Re: Response to Comments for Notice of Intent/Stormwater Report

Former Polymerine
241 Duchaine Boulevard, New Bedford, MA
DEP File # SE049-0730

ATTACHMENT A – REVISED SHEET 6 OF NOI PERMIT PLANS

PROPOSED PAVEMENT CAP
LAYOUT AND GRADING PLAN

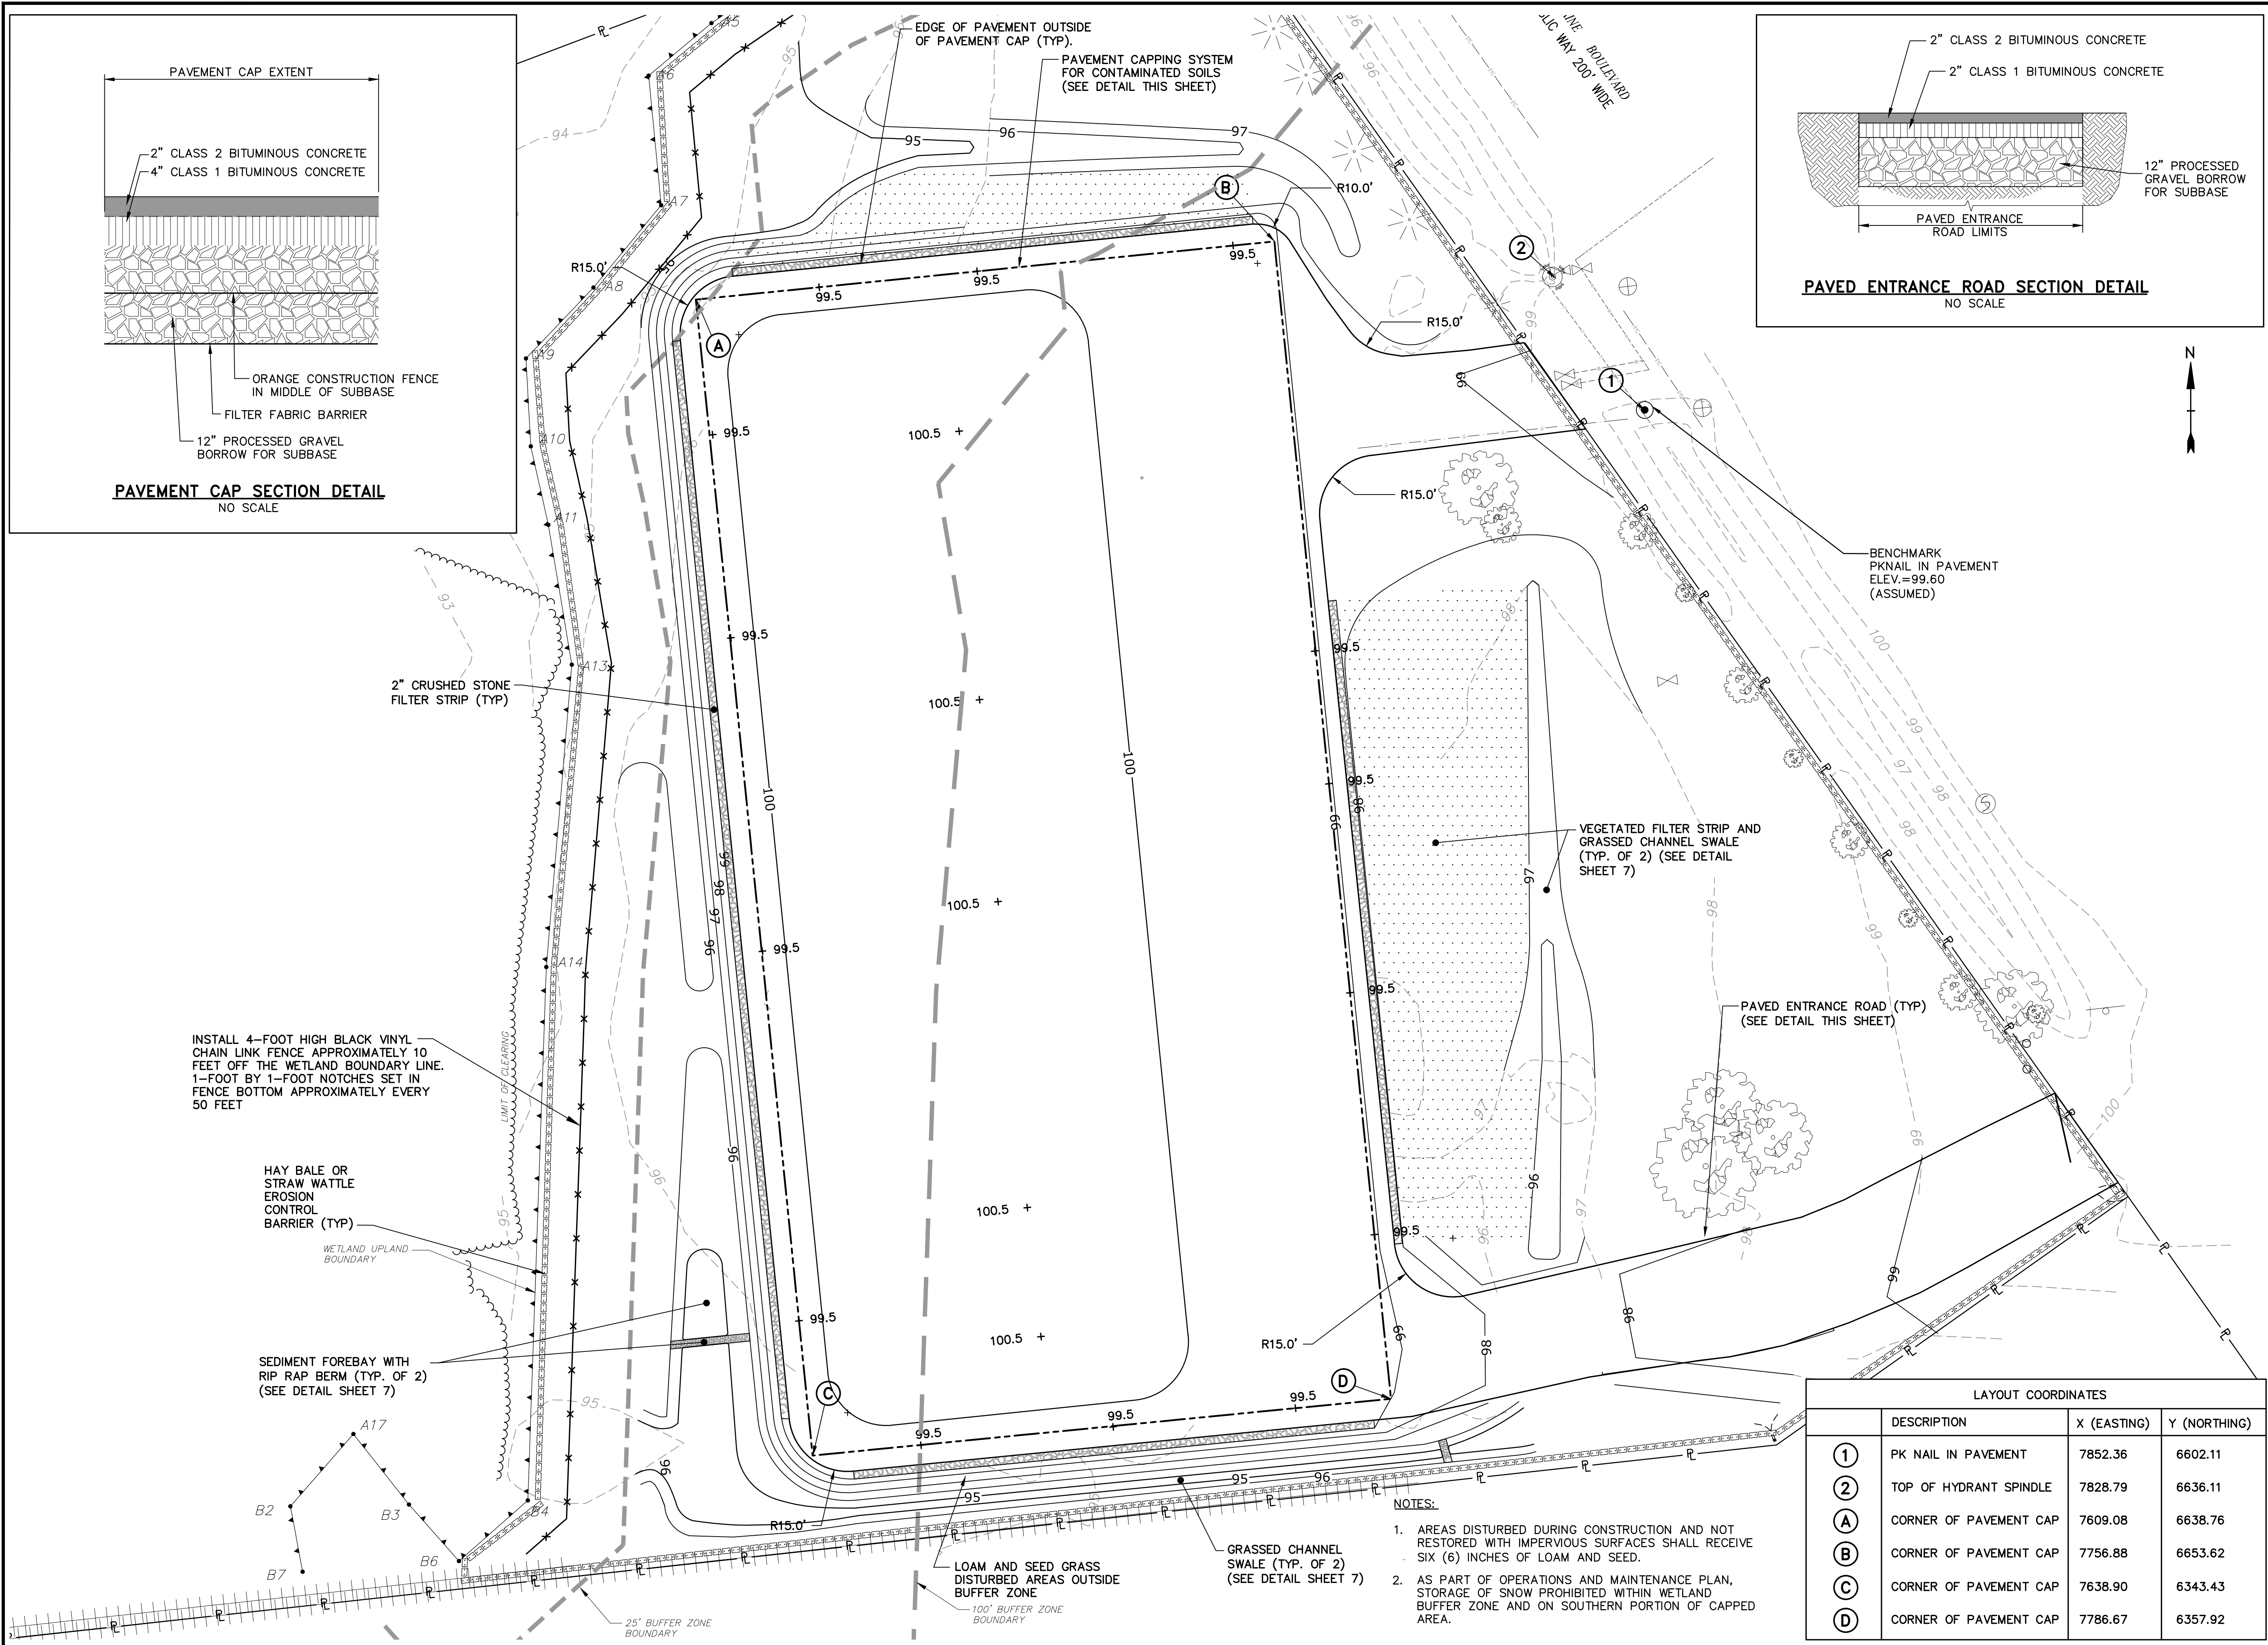
- **Comment No. 5:** *"The NOI describes that the site will be used as a parking lot. Typically, parking lots are required to include water quality treatment to remove 80% of suspended solids generated by the vehicles entering the site and parking in the parking lot. The proposed project does not include any water quality treatment.....We recommend that water quality best management practices (BMPs) be included on the project consistent with the Guidelines. Details of the BMPs should also be included on the plans."*

- **Comment No. 8:** *"The grading plan shows a 4-foot 3:1 slope along the southern property line. We recommend a swale be constructed on the property to insure that stormwater does not flow onto the adjacent property."*

Response: Tighe & Bond has revised the grading plan shown on Sheet 6 of the plan set to include Best Management Practices (BMP's) consistent with Mass Stormwater Handbook Guidelines. The BMP's chosen, given this site's unique situation, include vegetated filter strips in combination with grassed channels, as well as sediment forebays in combination with grassed channels to provide TSS removal to the maximum extent practicable. Calculations made relative to sizing of the BMP's, as well as anticipated TSS removal have been tabulated in spreadsheet form, and provided as attachments to this letter for your reference.

Infiltration and Structural based BMP's were not recommended due to the site's contaminated nature, therefore an optimal combination of Pre-Treatment and Conveyance BMP's were selected to provide TSS removal for the paved cap. Although the recommended 80% TSS removal was not achieved with the BMP combinations chosen, it is felt that given the nature of the contaminated site, and its unknown proposed end-use, the resultant TSS removals were the most practicable solution.

Response: In the process of revised site grading, and design of BMP's for TSS removal, a grassed channel swale with sediment forebay was sited against the southern slope of the proposed pavement cap to comply with the required TSS removal for the site, as well as to insure that stormwater runoff does not flow onto the adjacent property.
